Date: May 13, 2024

Re: Responses to City Comments  
PL2024098  
ANDY'S FROZEN CUSTARD - SUMMIT ORCHARD WEST  
PEI #240159

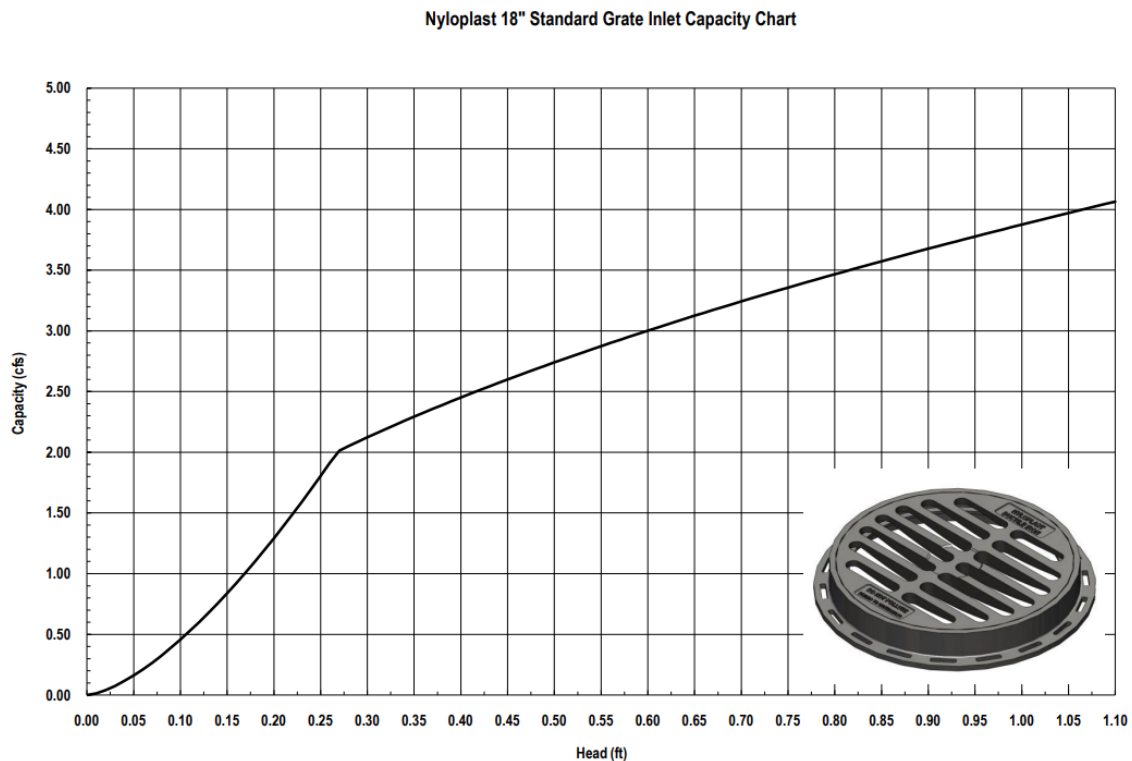
3. Please add pipe profiles for the 8-inch secondary storm lines. Add storm (inlet and pipe) calculations to the plans.

Response: Pipe profiles and drainage calculations added to Sheet C5.1 for the secondary storm system. Each secondary storm inlet captured <0.5 cfs during the 100-year event. This will result in less than 0.1 ft of head over the inlet per the chart below:
